Technical Service Bulletin: tsb100794

Released Date: 05-Feb-2009

New Cylinder Block

Cylinder block illustrating the location of the eliminated holes (1).

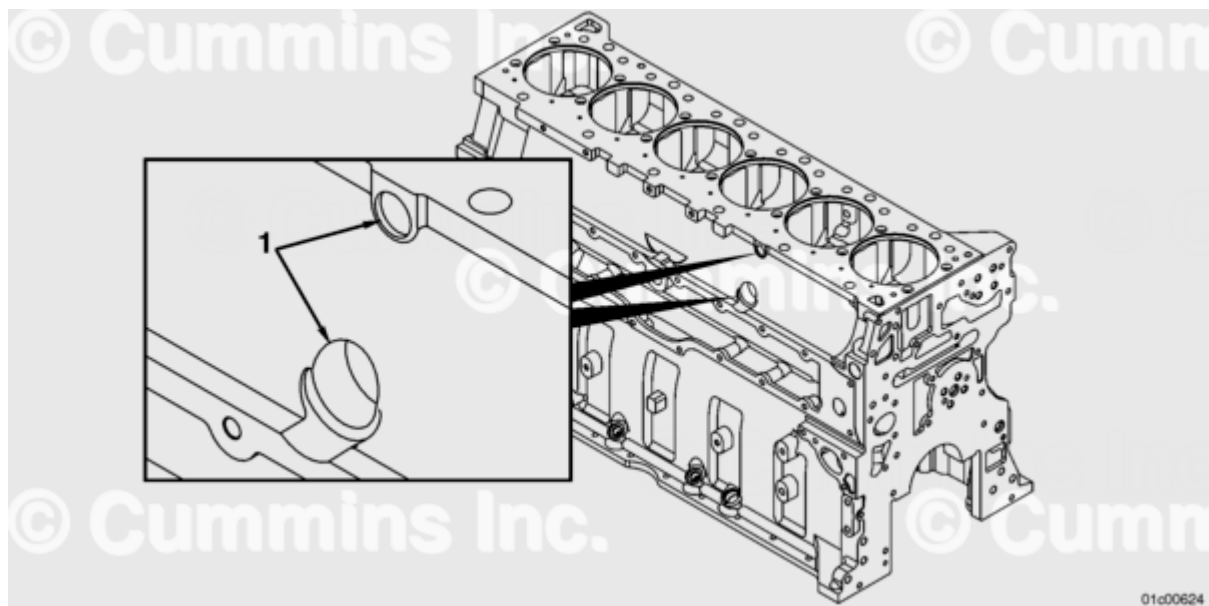
This Technical Service Bulletin introduces a new ISX cylinder block. The new cylinder block eliminates the access holes for the exhaust gas coolant supply and vent ports. The Part Number for this block is 3684716. Service procedures for the block will remain unchanged. Service block kits, Part Numbers 4955718 and 4955719, will be unaffected and will continue to utilize the block which contains access holes for the EGR coolant supply and vent ports (block Part Number 4965679).
